GP 19

December 23, 2002

This letter is a response to the draft finding of no significant impact (**FONSI**) for the proposed lease to the Muslim Youth Camp of America (MYCA) released by the Army Corps of Engineers (Corps) November 19th, 2002. The **FONSI** is based on an Environmental Assessment (EA) prepared by Zambrana Engineering, Inc. of St. Louis Missouri (Zambrana). The EA was approved by Colonel William J. Bayles, District Engineer. **I** find that a **FONSI** cannot be determined because the EA has significant errors and omissions. The range and degree of errors in the EA make it impossible to determine that the proposed use would have no significant environmental impact.

Figure 1: Coralville Lake Pool elevations

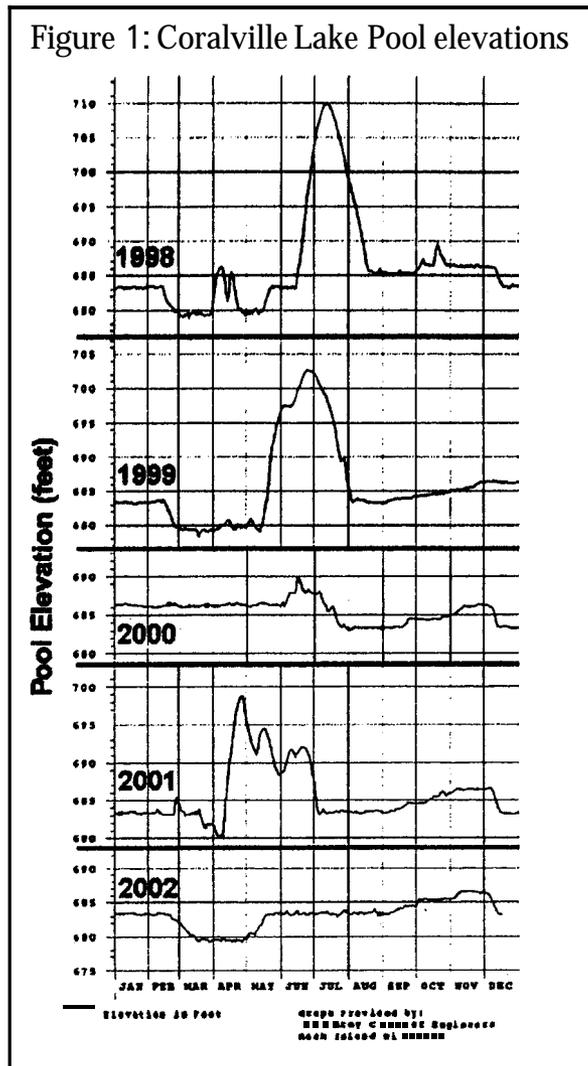
The north-south span of the site provided in Figure 5-1 is greatly exaggerated. Using the scale provided, the north-south span of the site 300 feet west of the **main** Girl Scout well (GS Well 1) is 780 feet. However, by **GPS** the span of the site at this location (300 feet west of GS Well 1) is 615 feet (± 15 feet). The GPS readings were taken when the Coralville lake pool elevation was at 686 feet. The EA does not report the pool elevation used for Figure 5-1. However, 686 feet is a low figure to use. Figure 1 (next page) shows the pool elevations of Coralville Lake for the last 5 years. **This** information was readily available to Zambrana. Note that for most years the pool elevation was greater than 690 for more than two months each year. Flood stage is not reached until the pool elevation is above 707 feet. The months when the **pool** level is 690 or above coincide with the highest use periods for the camp. The proper pool elevation to use for Figure 5-1 would **be** 690 feet or higher. The span of the site is less than 615 feet if an appropriate pool elevation is used.

The EA is not a valid study. The EA incorrectly determined the north-south span of the property as approximately 780 feet, at least 165 feet greater (nearly 30% error) than the actual width. It is difficult to understand the lack of precision evident in the EA. A FONSI cannot be determined because the **EA** is not a valid study.

Another problem with the **EA** is that it only sites the need for one absorption field. This does not allow for failure of the **field** during the life of the project. Failure of the absorption field is not only likely, it is expected. First, FAST systems are not recommended for the episodic and seasonal uses proposed. The bacterial biomass will "crash" during periods of lower use and not **be** able to adequately process the waste generated at peak use. Second, FAST systems are not

recommended for water usages greater than 9,000 GPD. The estimated water demand for the project's proposed use is 11,200 GPD. The estimated water demand for the project's design capacity is 16,895 GPD. The FAST system is expected to fail due to excessive demand using either estimation. Third, the absorption field is in a wooded environment and will become root bound. The absorption field is expected to fail due to root plugs. And fourth, even if the system managed to operate efficiently beyond normally recommended parameters and avoided plugging by roots, the absorption field still would be expected to fail within the life of the complex and require prolonged rest. Proper planning requires that area for more than one septic field be available. Indeed, residential lots in the Coralville Lake watershed area are required to be 3 or more acres for the only purpose of allowing for replacement of failed septic fields. The absorption field area required for the designed occupancy will be 1.95 acres plus at least another 1.95 acres to allow for field failure. Approximately 4 acres is the absolute minimum area needed and 6 acres would be preferable to allow for the expected future failure of the drainage field.
